**STATE OF INDIANA  
INDIANA UTILITY REGULATORY COMMISSION**

**CAUSE NO. 44242**

**SUBMISSION OF REDACTED TESTIMONY AND EXHIBITS OF  
JEREMY I. FISHER, PhD, and PETER J. LANZALOTTA**

**Direct Testimony of  
Jeremy I. Fisher, PhD**

2 **Figure 1. Hypothetical dispatch spread for coal and natural gas plants. Y-axis is the**  
 3 **dispatch spread in \$/MWh.**

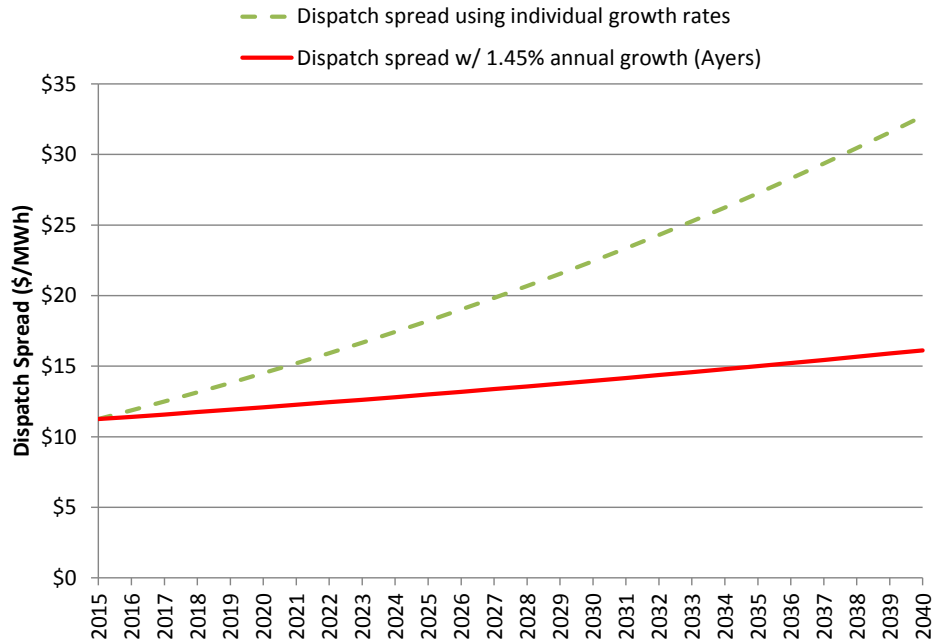
1 Taking the difference between the annual growth rates of each of these  
2 components ( $2.25\% - 0.8\% = 1.45\%$ ) is not the same as the annual growth rate of  
3 the difference.<sup>30</sup>

4 The correct method, given Mr. Ayers' apparent intentions, would have been to  
5 simply apply the individual annual growth rates of each component (2.25% and  
6 0.8%, respectively) and then take the difference between the two results—this is  
7 the dispatch spread. Instead, Mr. Ayers applies the growth rate difference (1.45%)  
8 to the spread.

9 Figure 1 shows a simple, hypothetical case for a coal and natural gas plant to  
10 show the Company's calculations along with the mathematically correct method.  
11 This example starts with the \$[REDACTED]/MWh spread projected by the Company for  
12 2015 then projects the spread through 2040. The Company's method (in red)  
13 assumes a constant 1.45% annual growth rate while (in green) the annual growth  
14 predicted from increasing the operating costs by 2.25% annually for natural gas  
15 and 0.8% for coal, leads to a different annual growth rate of the spread in each  
16 year—starting at 5.5% in the first year, then decreasing in each year. The  
17 differences in methodology shown in this example demonstrate widely different  
18 levels for the dispatch spread: the Company's method yields a dispatch spread of  
19 \$16 in 2040. The mathematically correct method yields a dispatch spread of \$33

5 **A** The correction of this error shifts the analysis in favor of the retrofit decision; yet  
 6 as I will show later, this correction is not sufficient to show that retrofitting all of  
 7 the IPL Big Five units will remain economic.

12 **Figure 2. Margin between gas and coal production cost at base coal prices.**

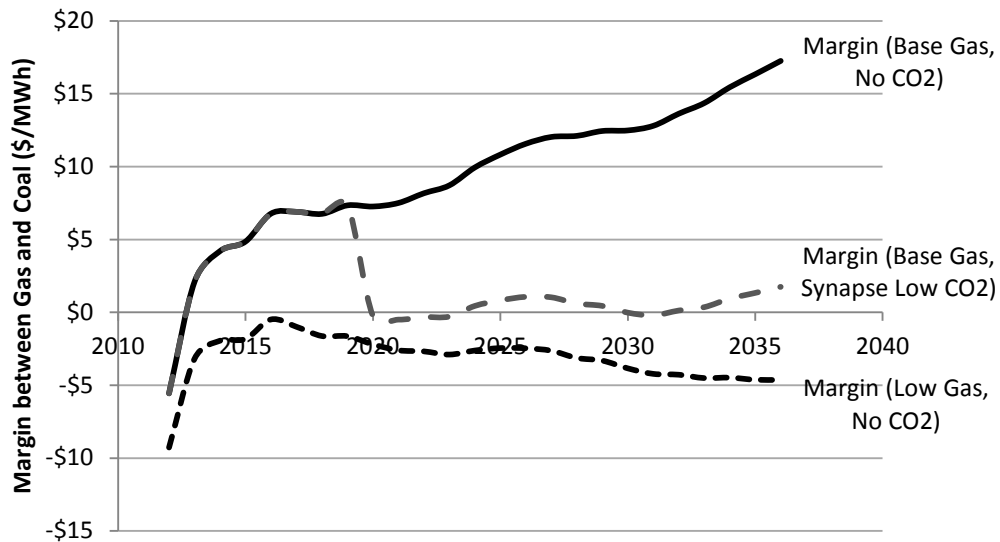
22 I illustrate a series of conditions below in which the “dispatch spread” shrinks or  
23 inverts at reasonably anticipated projected commodity prices. Using CERA’s  
24 assumptions for heat rates and the Company’s Ventyx-supplied coal and gas  
25 prices (as utilized in Mr. Ayers’ analysis),<sup>68</sup> I created an estimate of the  
26 production cost margin under base conditions in Figure 2, below (solid black

11 **Figure 3. Model results from EMF indicating natural gas changes with rising CO<sub>2</sub>**  
12 **prices.<sup>76</sup>**

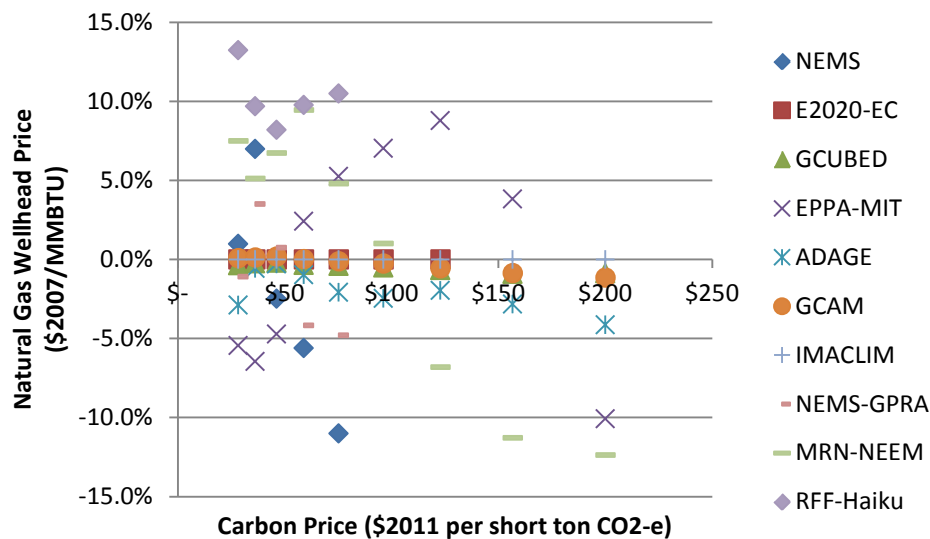
8 In Figure 3, below, I have plotted the percentage change in natural gas prices in  
9 relation to a range of carbon prices as output by each model in this study.

13 Figure 3 shows clearly that some of the most advanced integrated energy  
14 economics models disagree with one another regarding the extent of gas price  
15 sensitivity to carbon prices. Of the ten models portrayed here, four predict lower
